Technical Bulletin

Bulletin Number: 407 Revision Number: R-01

SUBJECT: Adjustable Brown Cam for Narrow Column Vend Motor Part #B801,806,610.21

MODELS: All Series 90 Venders with Narrow Columns

**Adjustable Brown Cam
801,806,610.21**

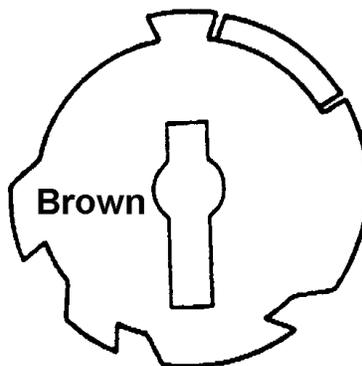
REASON: The bottom of hole #2 was blocked off with a .010" wall thickness. This will prevent anyone from using this setting unintentionally. To use hole #2 it will be necessary to punch through it using the lobe on the bottom cam. This change went into effect in December 1990.
